Device	XMC1400
Marking/Step	EES-AA, ES-AA, AA
Package	PG-VQFN-40/48/64, PG-LQFP-64, PG-TSSOP-38

Overview

This “Errata Sheet” describes product deviations with respect to the user documentation listed below.

Figure 1 CCU8 simplifier PWM generation scheme - a) normal mode; b) asymmetric mode

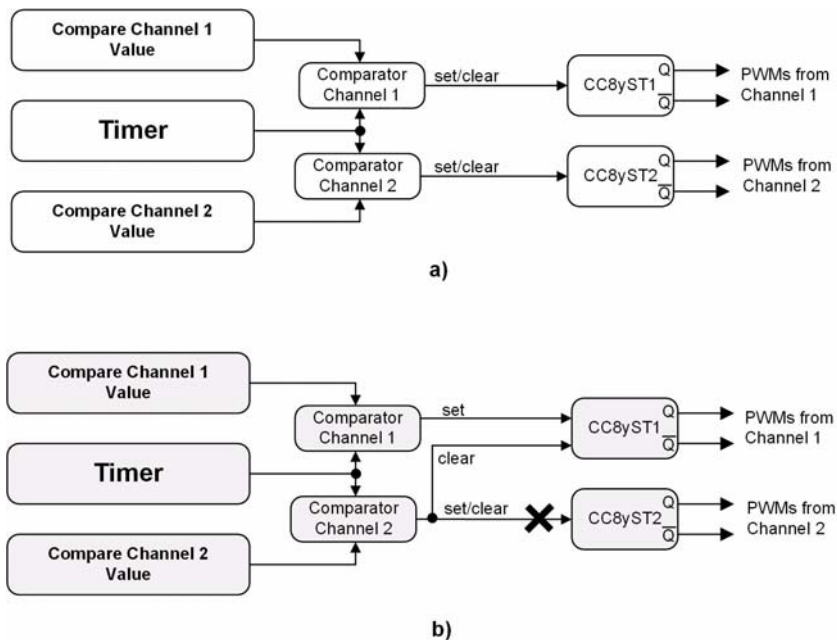
The asymmetric mode has a bug, where the PWM signal of Compare Channel 2 is not stored in CC8yST2. This means that from the Compare Channel 2 the timer cannot generate any PWM signal - depicted by the cross on **Figure 1 b)**.

None

Figure 2 CCU8x concatenation feature resource configuration - a) without external count function; b) with external count function

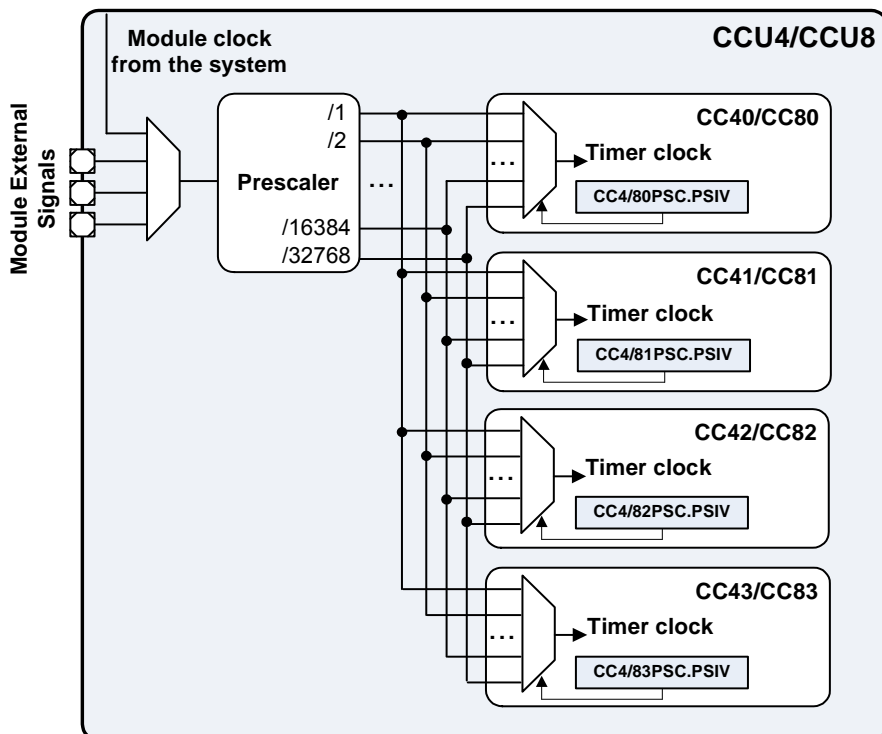
When an external count signal is enabled - by programming the CC8yCMC.CNTS with 01_B , 10_B or 11_B - the concatenation function does not work. One cannot use in parallel the timer concatenation and external count signal features.

Note: On Figure 1, the count signal is used in CCU80 because this timer represents the LSBs. While the count signal could be enabled in the MSB timer (CC81), this does not make sense when the timers are concatenate - because the count should be used to increment the LSB timer. The LSB timer will then in each wrap around, increment the MSB timer.

None
